188 Beaumont Street Fast-track

Auckland Council Specialist Memo

Groundwater

2.0 Technical Specialist Memo - Groundwater

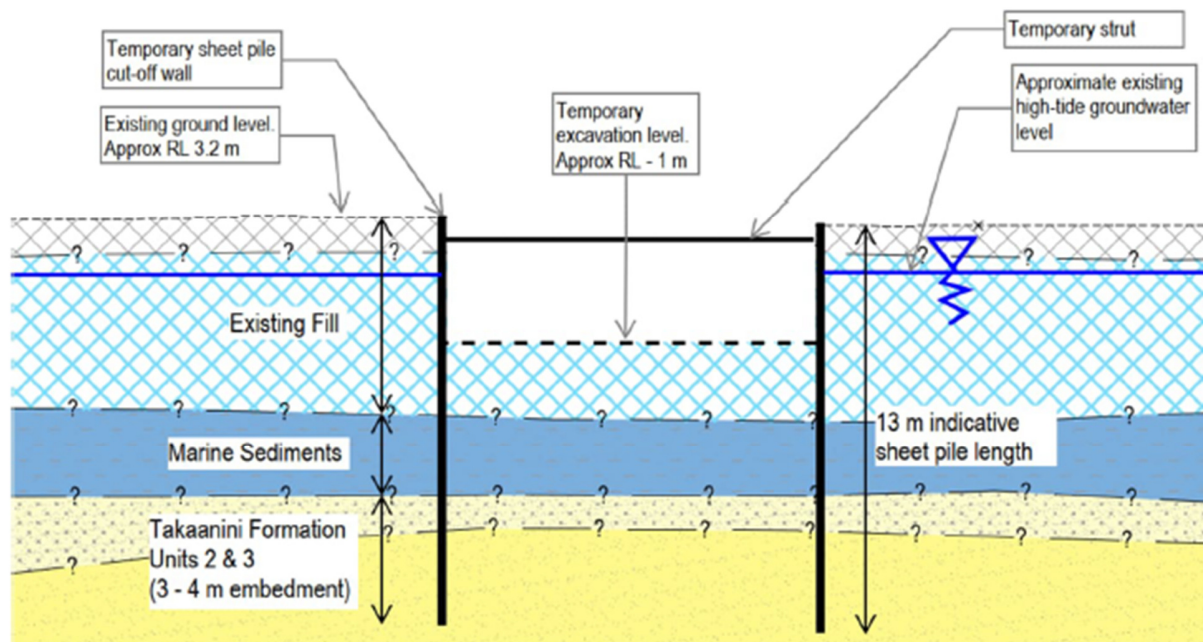
IGS indicate that specific geotechnical and structure design will be required to detail the cut-off wall and the dimensions presented for a temporary sheet pile option in Figure 1 below are indicative only.

I concur with the above statements and consider that the options for the proposed retaining for the lift pit/core excavations are appropriate.
